Service Bulletin Nº 111

SUBJ: NEW!!   EXTRA! EXTRA!
South Park Pinball uses 8MB EPROM's
for Expanded Speech & Sound Capabilities

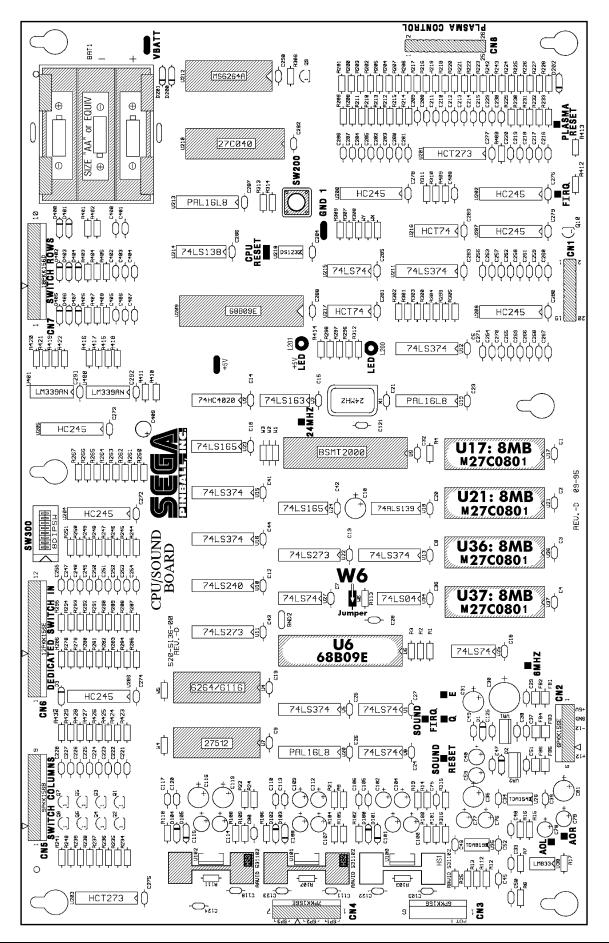
Located on the **CPU/Sound Board** at **Voice Rom Locations U17, U21, U36, U37** you will find **8-MEGABYTE EPROMs** (M27C801-100FI / SPI Part Nº 960-5016-00, blank EPROM). Boards that use the **8MB EPROMs** have Jumper "**W6**" installed (located to the right of "**U6**" 68B09E Microprocessor, see the *Component Layout* on the next page) these are *BACKWARD COMPATIBLE* with all 4MB applications. Games that use the **4MB Voice ROMs** *do not have* "**W6**" installed and *WILL NOT WORK CORRECTLY* with **8MB EPROMs** ("**W6**" *must be installed*). *All future games* will have CPU/Sound Board's with the jumper installed regardless of the type of voice ROMs being used to ensure compatibility.

What does the **"W6" Jumper** do? Pin-1 of the original **4MB EPROM** is **"Vpp"** which is used for programming when 12.5v DC is applied or used as an **Address Line** when in the 0v DC - 5v DC range. On our CPU/Sound Board, when "**W6**" is installed, this Pin is tied to **PA19** when removed Pin-1 is not used. If **8MB EPROMs** are used *without* "**W6**" installed, the symtoms will be garbled sound similiar to a bird chirping or an *old 33-1/3 LP* being played at *78 RPM (you older techs might remember what that sounded like).*
